From: Patricia Harrell <Pat_Harrell@msn.com>
Sent: Friday, January 27, 2017 11:42 AM
To: Lindsey Ozbolt
Subject: Re: East Lake Sammamish Trail-South Sammamish Segment B section-60% Design Plan comments

Thank you for contacting the City of Sammamish regarding the current Shoreline Substantial Development Permit Application for East Lake Sammamish Trail Segment 2B (SSDP2016-00415).

RE: King County SSDP Permit-- South Sammamish Segment B
Homeowner comments regarding 60% Design Plan
Survey Station 332+00
2221 East Lake Sammamish PL SE

SHEET NO.
39 OF 135
AL7

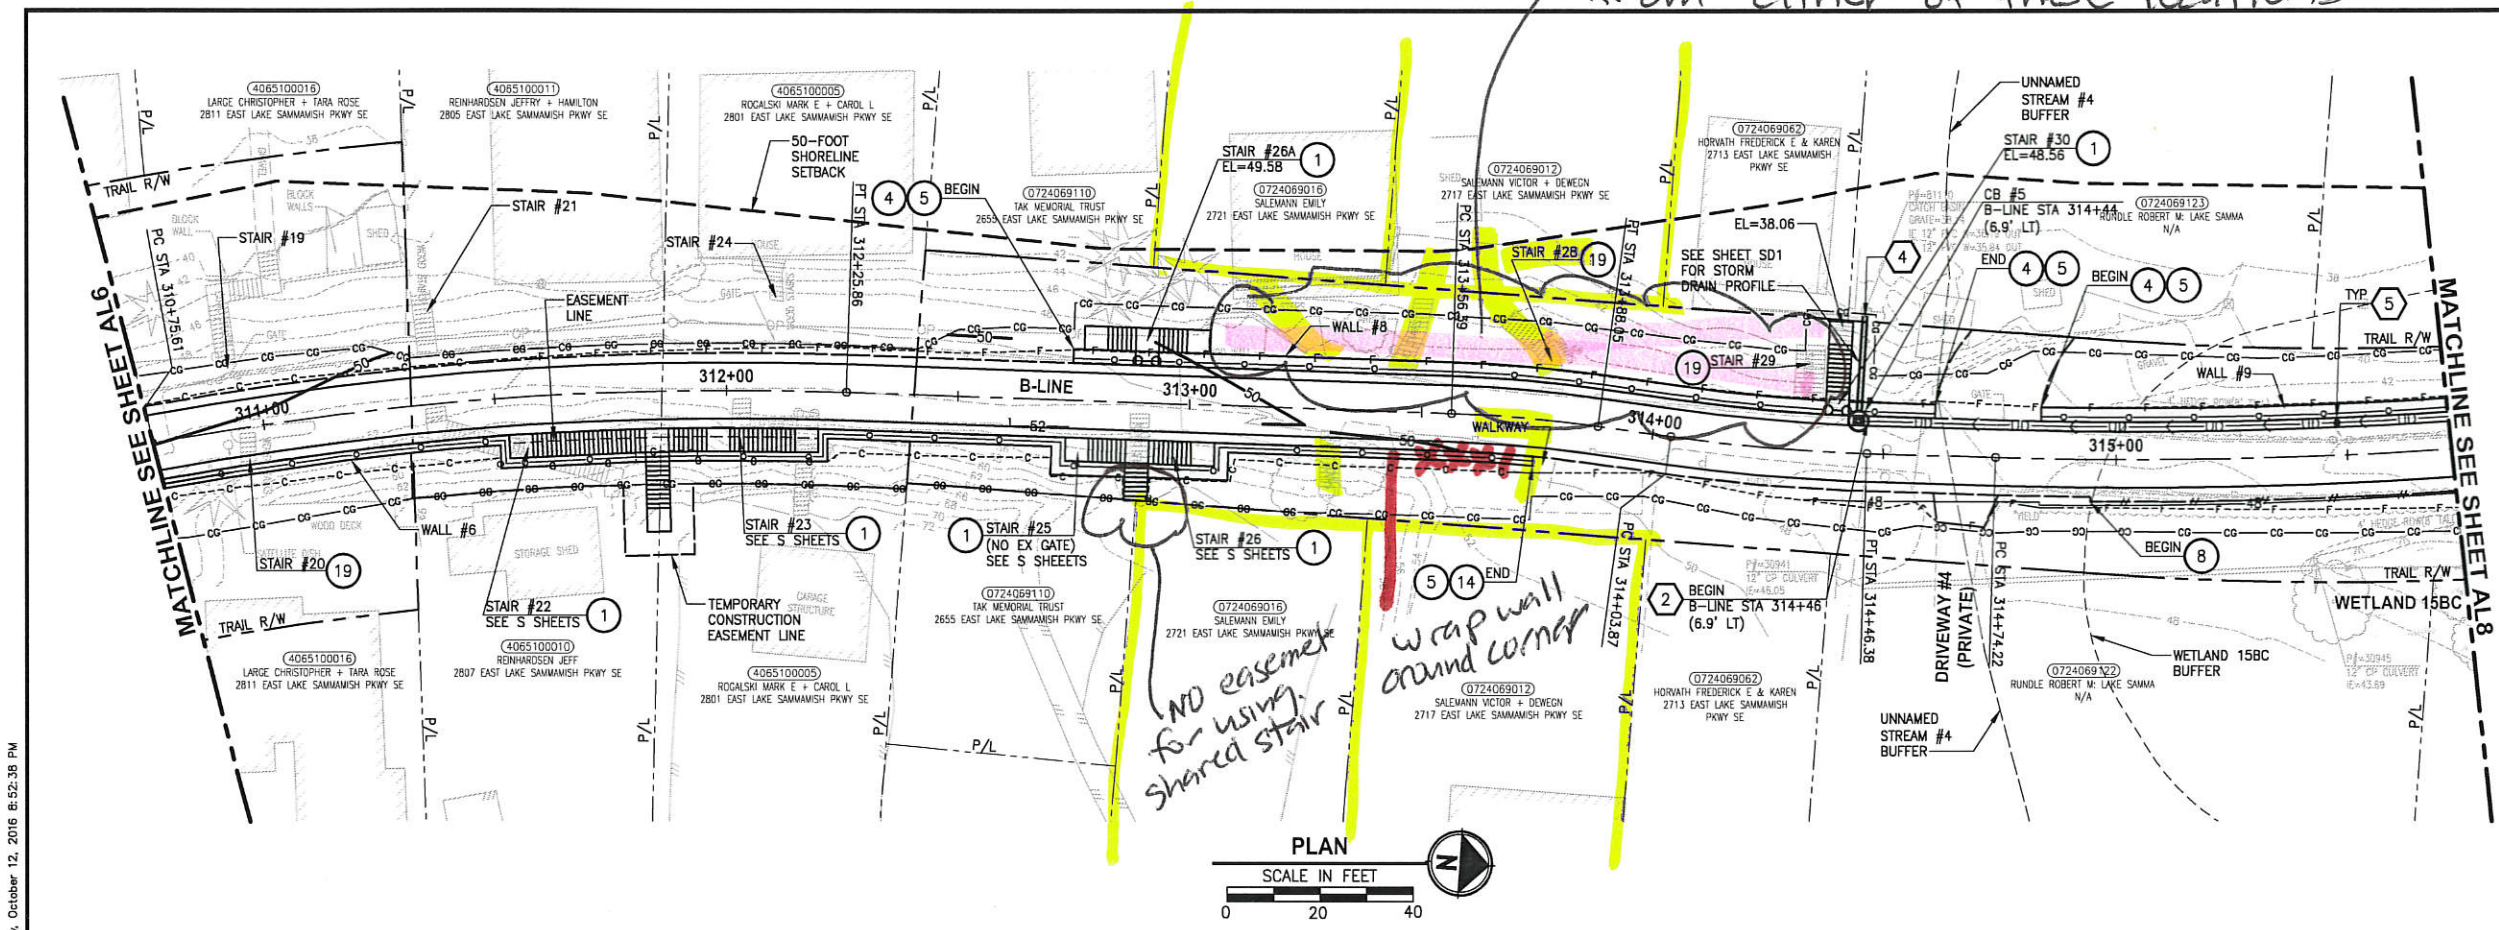
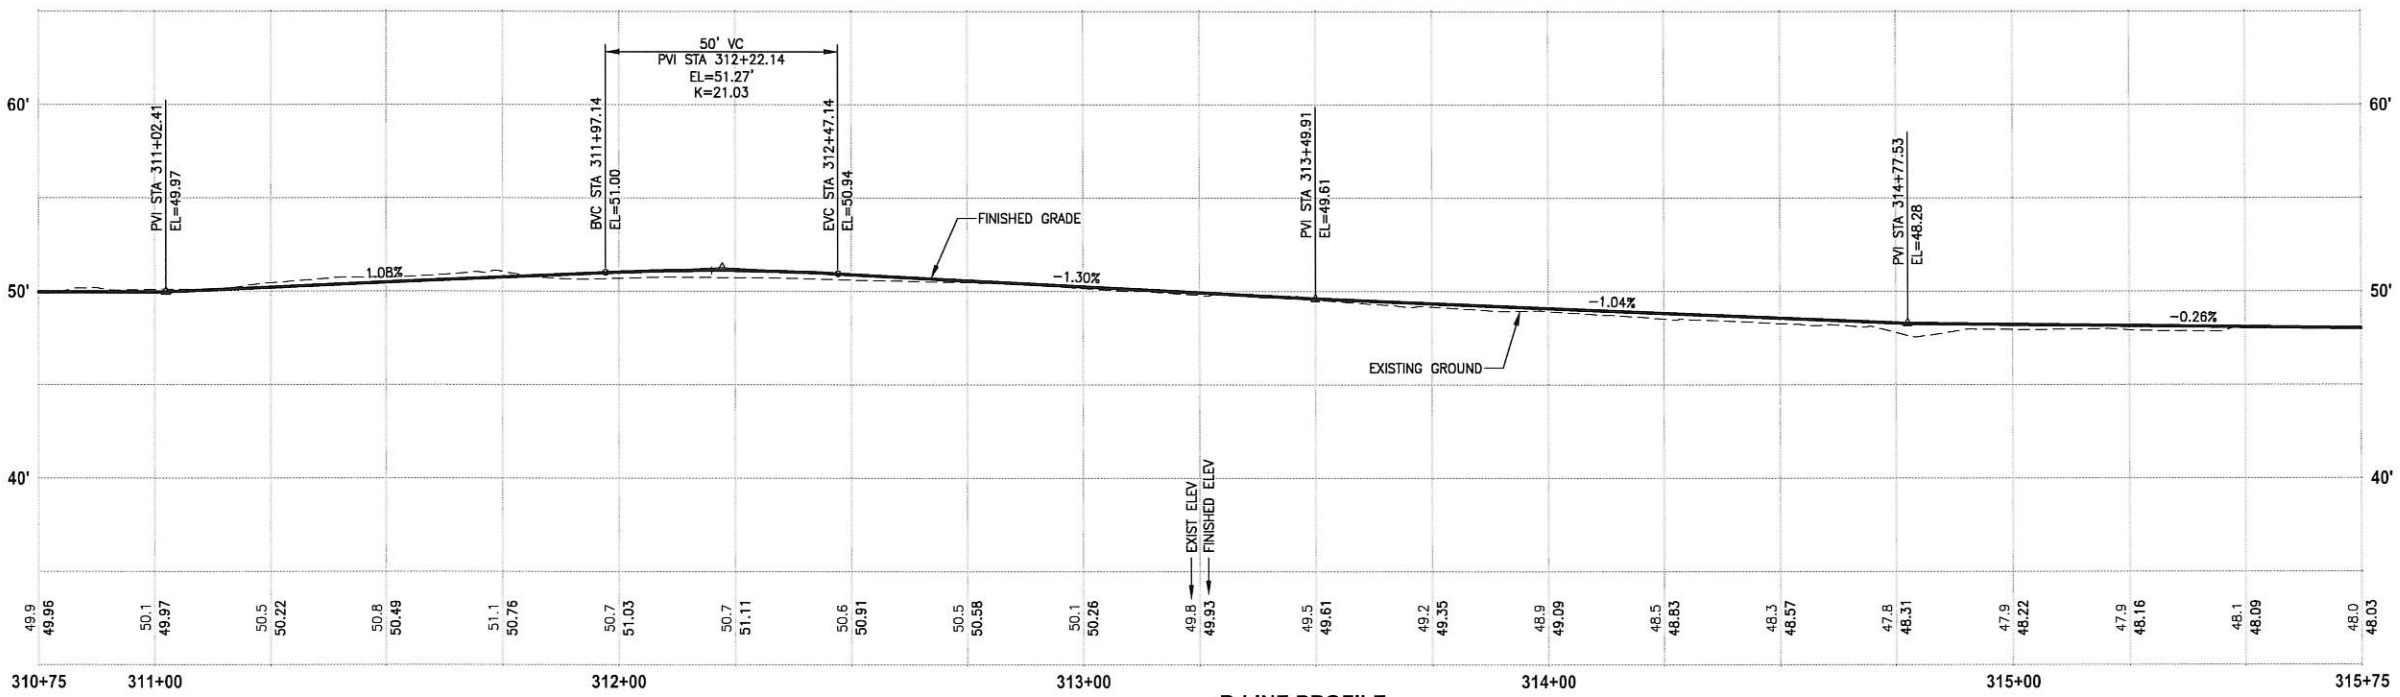
The shoulder pile wall is shown differently on the plan vs the wall detail sheet. The wall detail sheet looks better. I would prefer the wall end at our property line and wrap to the east if needed.

Not feasible to get to our beach from either of these locations

SHEET NO.
109 OF 135
S4

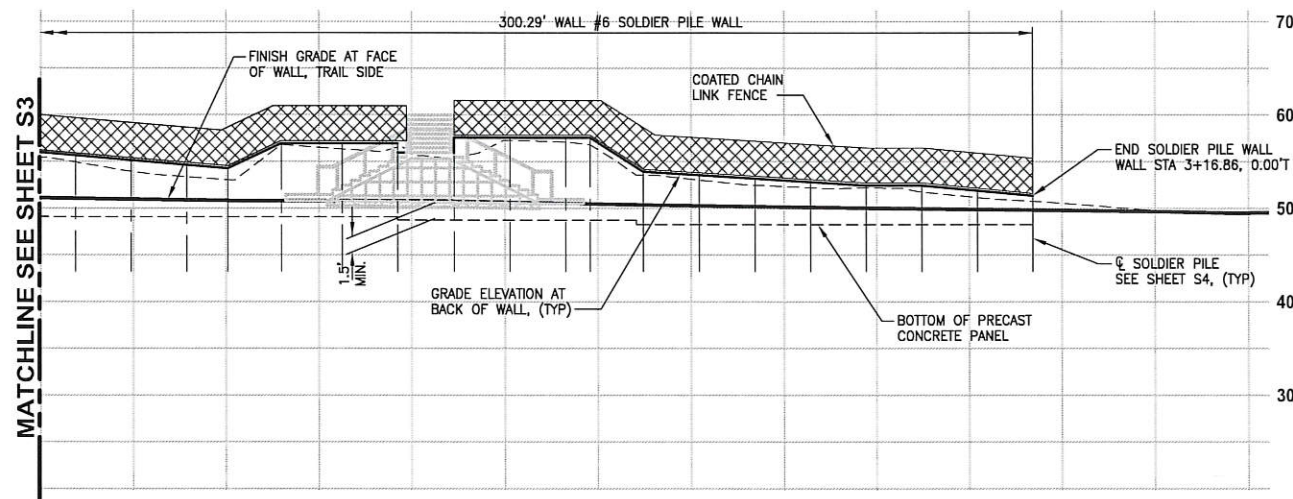
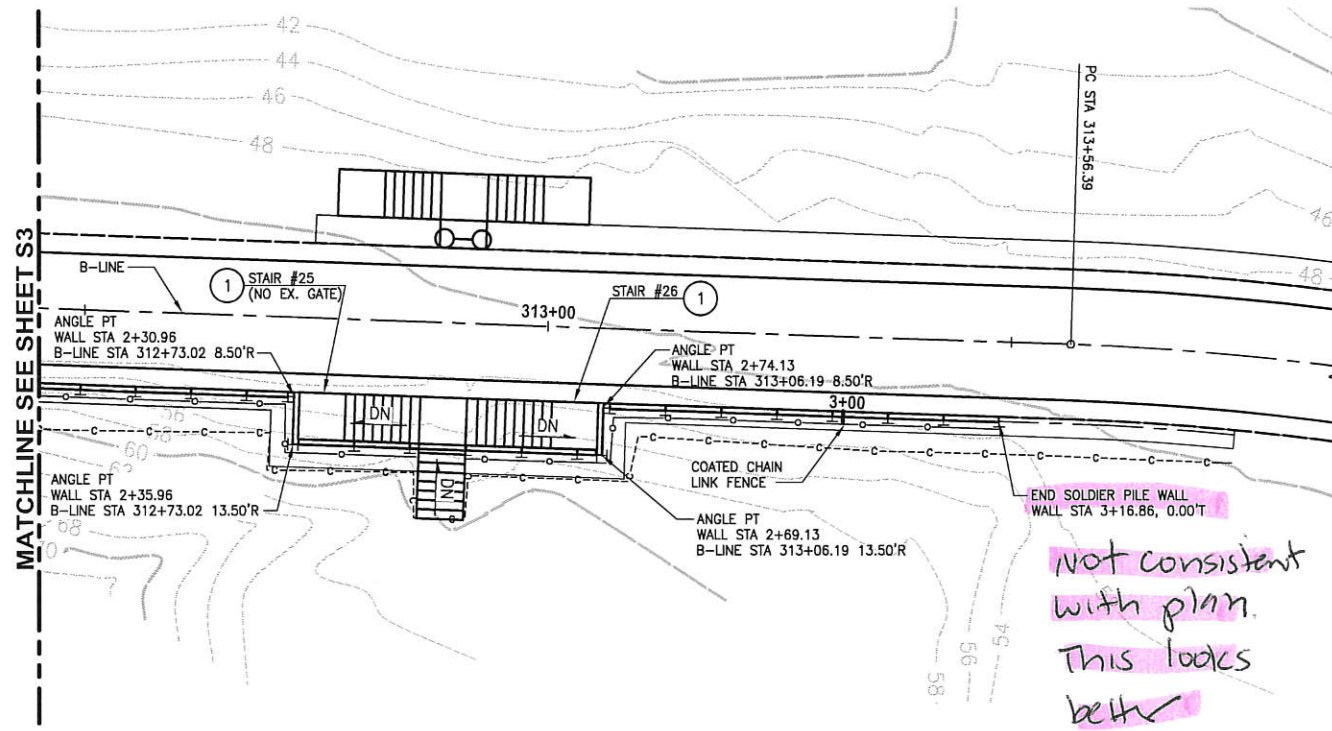
Not consistent with plan. This looks better
